Technical Service Note 31-10

SUBJECT: Inverted U End of Frame Closing Crossmember Fastener Replacement.

PRODUCTS: Cascadia vehicles equipped with the inverted U end of frame closing crossmember.

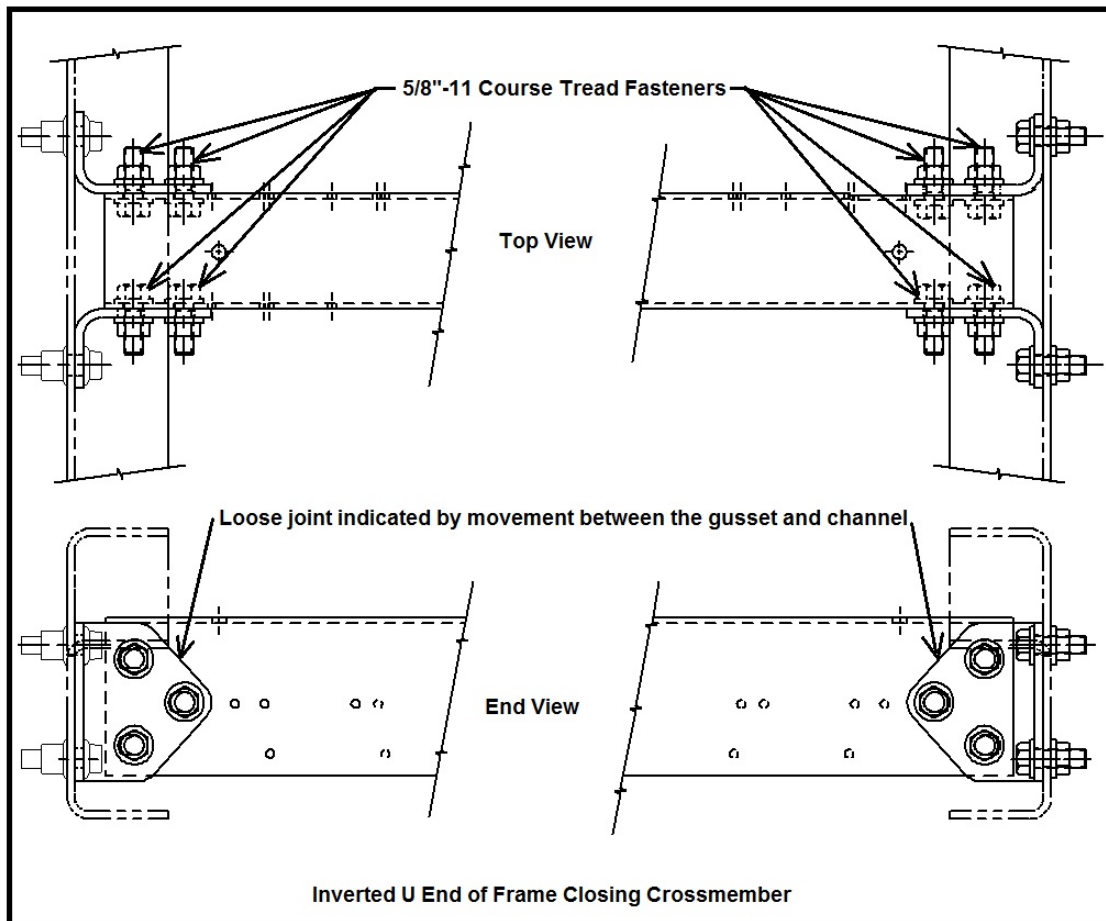
Inspect the c-channel and gusset for any relative movement. Check the 5/8” fasteners to confirm they are torqued to the appropriate specification. Reference the following illustrations:

If there is any indication that the any of the fasteners are loose, replace all 12 fasteners with new hardware.

When tightening from the **bolt head** torque to **136 ft-lbs**

When tightening from the **nut** torque to **128 ft-lbs**
